FAQ Number 07-0030 FAQ Revision 1

FAQ Title Establishing Recovery Actions

Plant: Turkey Point Date: June 22, 2010

Markup of NEI 04-02 Revision 2 (Reflects FAQ 06-0011 and 0012)

Figure B-1 General Process to Transition Operator Manual Actions (Ref. NEI 04-02)

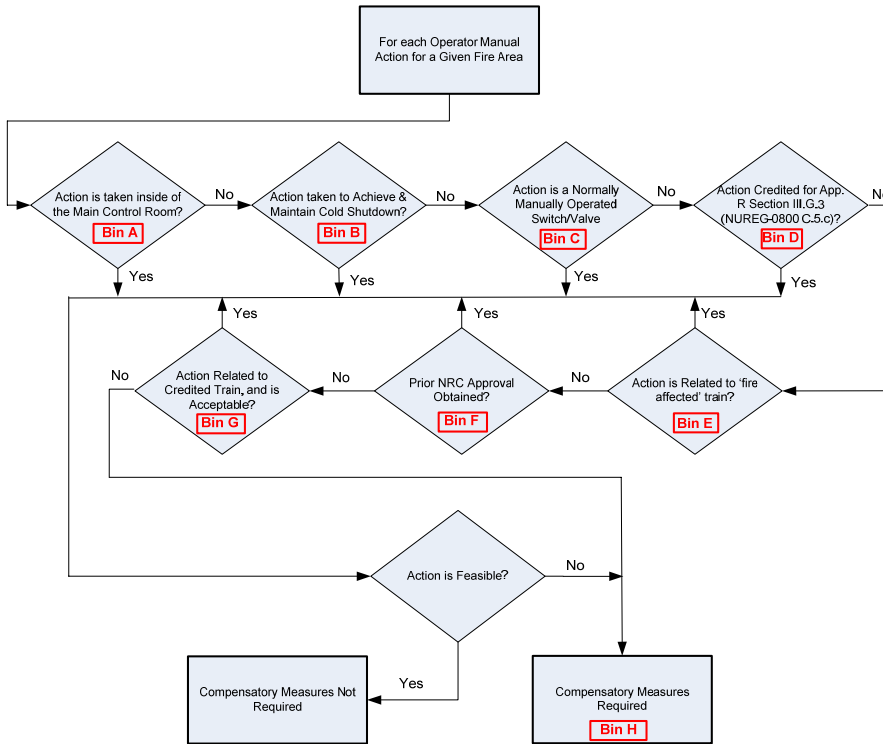
Figure B-1 depicts the general process for determining pre-transition OMAs and determining those that are in alignment with the current licensing basis. This process ‘bins’ pre-transition OMAs. The ‘bin’ identifiers are for ease of reference. In following the chart, once the action is defined for the first time it is “binned” and not considered for any other categorization.

Feasible pre-transition OMAs binned as A through G are allowed/approved under the 10 CFR 50 Appendix R licensing basis and, therefore, compensatory measures do not need to be established. Pre-transition OMAs binned as H are not allowed under the 10 CFR 50 Appendix R licensing basis and therefore a compensatory measure should be established. If the ‘Bin H’ pre-transition OMA has been demonstrated to be feasible it can be considered a compensatory measure (RIS 2006-10 and RIS 2005-07).

**Figure B-2 Allowed OMA in Fire Area Meeting 10 CFR 50, Appendix R,
Section III.G.1 Separation Criteria**

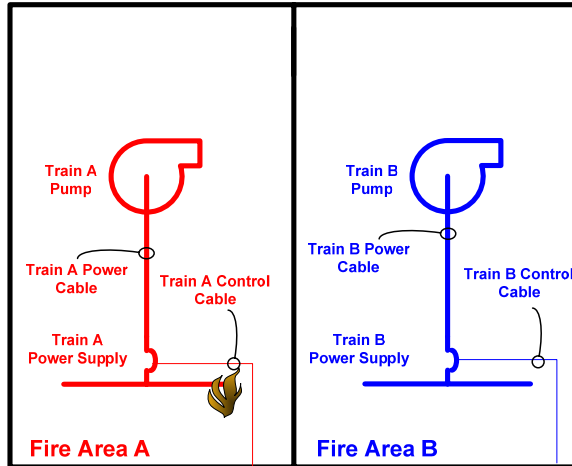
Fire Area A and B meet the separation criteria of 10 CFR 50 Appendix R Section III.G.1
A postulated fire in Fire Area A could result in the spurious starting of the Train A pump,
which can be mitigated by an operator manual action to de-energize the Train A Power
Supply to stop Pump A.

Figure B-3 Allowed OMA in Fire Area Meeting 10 CFR 50, Appendix R, Section III.G.2 Compliant – OMA for Fire Affected Train

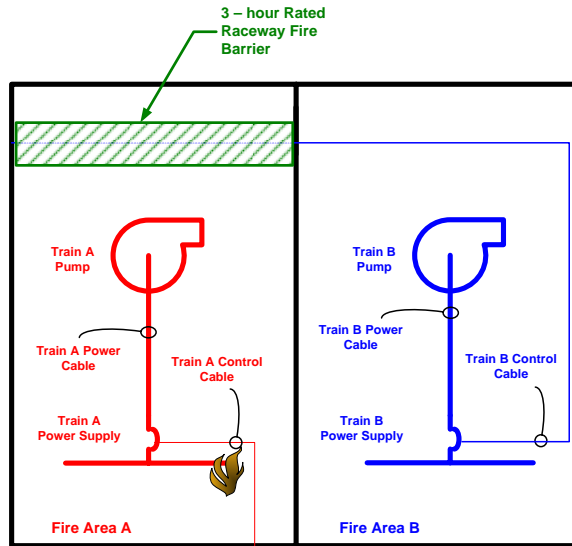
Fire Area B meets the separation criteria of 10 CFR 50 Appendix R Section III.G.2.a
A postulated fire in Fire Area A could result in the spurious starting of the non-credited Train A pump, which can be mitigated by an operator manual action to de-energize the Train A Power Supply to stop Pump A. This is functionally equivalent to Case in Figure B-5.

Figure B-4 Allowed Operator Manual Action – In Credited Success Path – Common Tank Suction

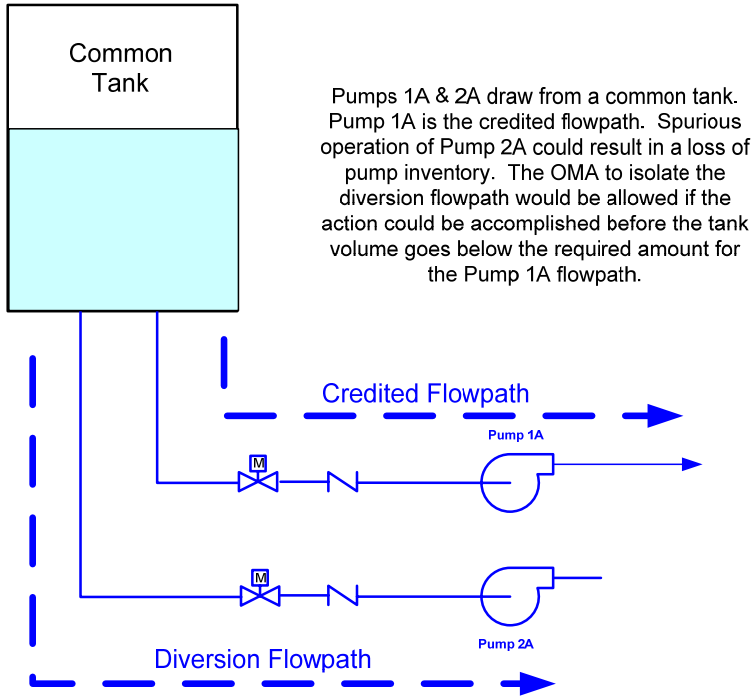
A special case of “fire affected train” exists where two redundant trains have components/cables in a given fire area, and both trains take suction from a common tank. In this case, a manual action would be allowed (and no risk evaluation would be required) to secure the fire affected train, since the credited train is protected (meets III.G.2 requirements) even though the manual action would need to be accomplished before the common tank level decreased to the point where operation of the credited train would be affected. This is acceptable since the common point in the system is the tank, which is still free of fire damage. This example was discussed in the June 9, 2006 public meeting. (ML061980016)

Figure B-5 OMA – In Credited Success Path – Auxiliary Feedwater Flow Diversion [not allowed per NRC Ref. ML072820168]

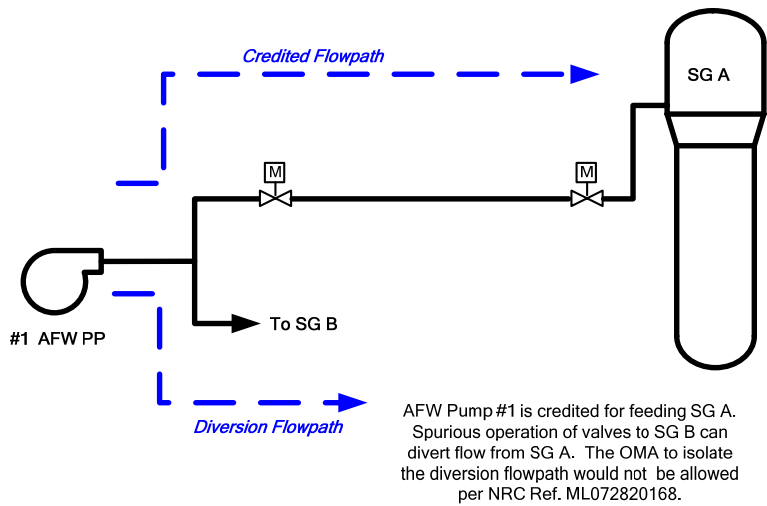
An example where an OMA to address spurious operations that affect the credited safe shutdown success path would not be allowed is the case where the credited function is to inject water to one of the Steam Generators (reactor) and a spurious operation causes a diversion from the credited flow path. Even though the minimum required injection flow can be maintained and the OMA can be accomplished prior to the function being disabled, the operator manual action is not allowed and a risk evaluation would be required since the credited train is not free of fire damage (the diversion of flow must be terminated at some point or the credited safe shutdown path will not be successful). An example of this configuration is BWR example 3 of the June 9, 2006 public meeting (ML061980016). This clarification of the ‘credited train not being free of fire damage’ was provided by the NRC on September 20, 2007. (ML072820168)
